ADDENDUM NUMBER: ONE

ISSUED BY: SEPW Architecture Inc.
109 – 3725 Pasqua St., Regina, SK. S4S 6W8
PH. (306) 569-2255

PROJECT: NEW POLICE BUILDING
ONION LAKE, SASKATCHEWAN

DRAWING TITLE
MILLWORK DETAIL

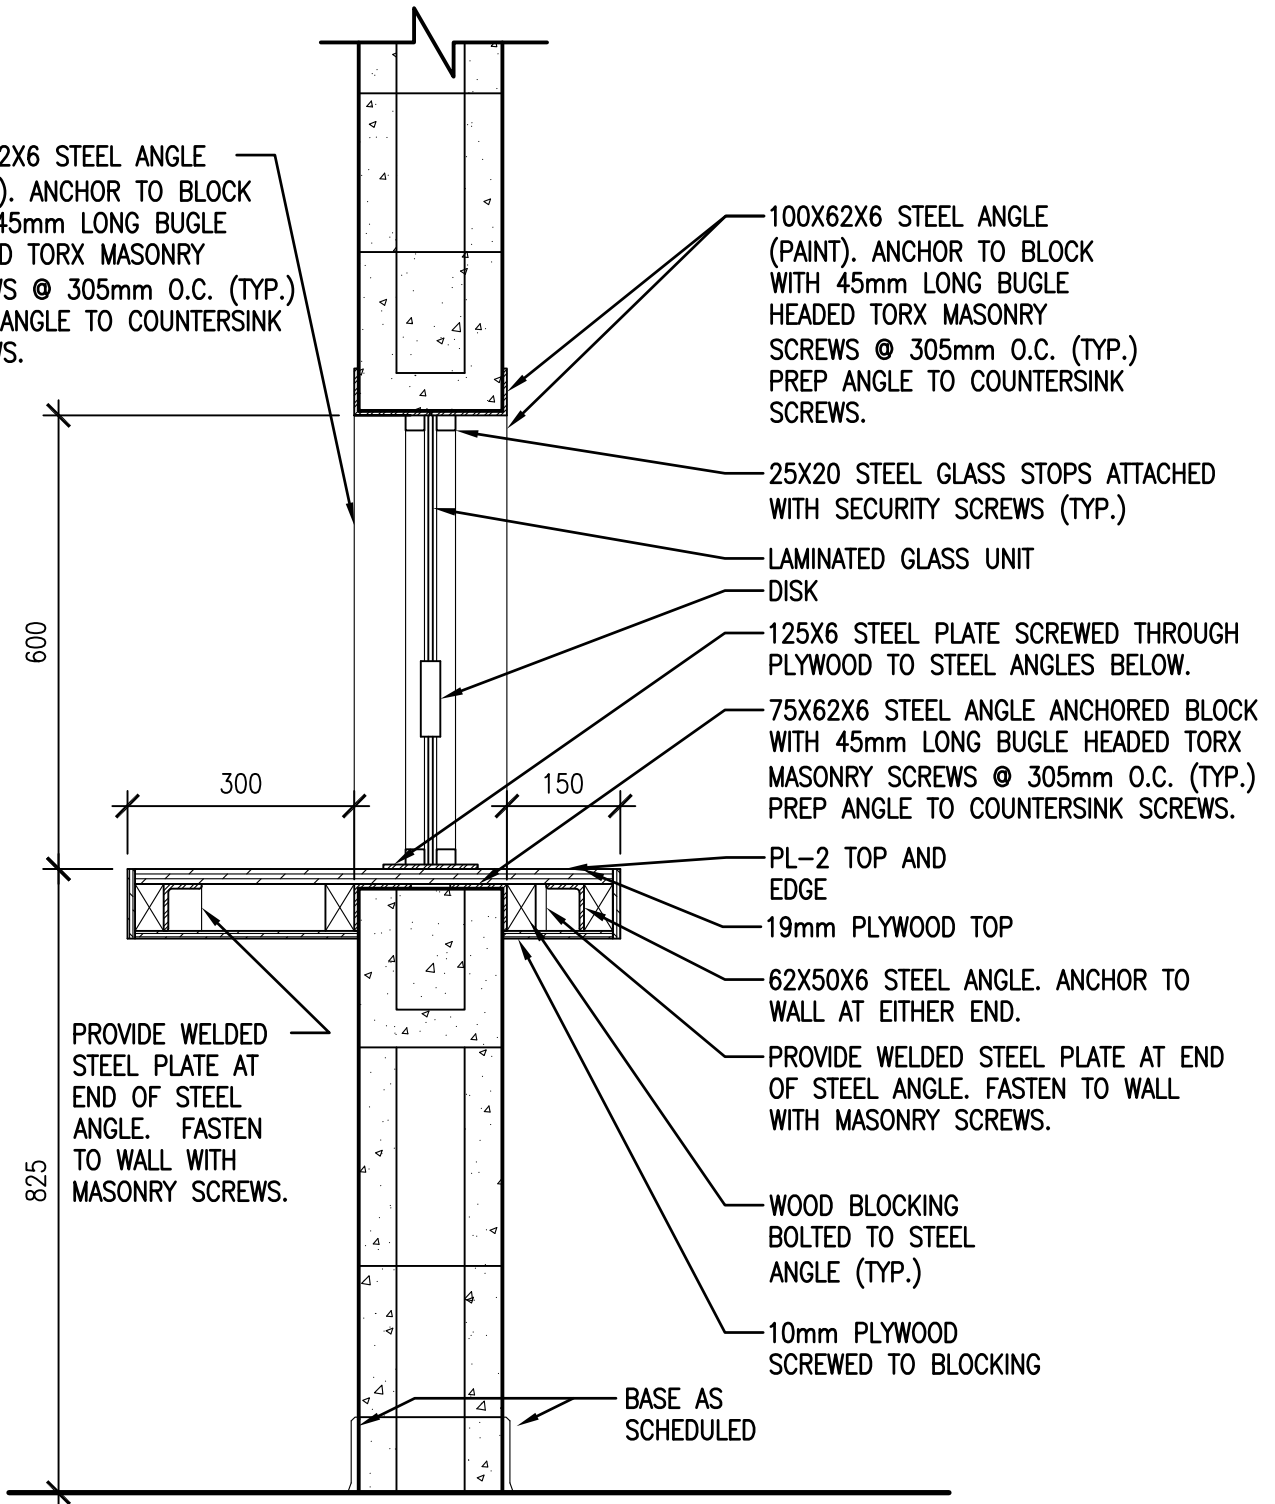
A-1-17 REF. DRAWING A6.2 MILLWORK DETAILS

1. Revise detail B21 as indicated in sketch AR1.

PL-2 TOP AND EDGE

19mm PLYWOOD TOP

62X50X6 STEEL ANGLE. ANCHOR TO WALL AT EITHER END.

PROVIDE WELDED STEEL PLATE AT END OF STEEL ANGLE. FASTEN TO WALL WITH MASONRY SCREWS.
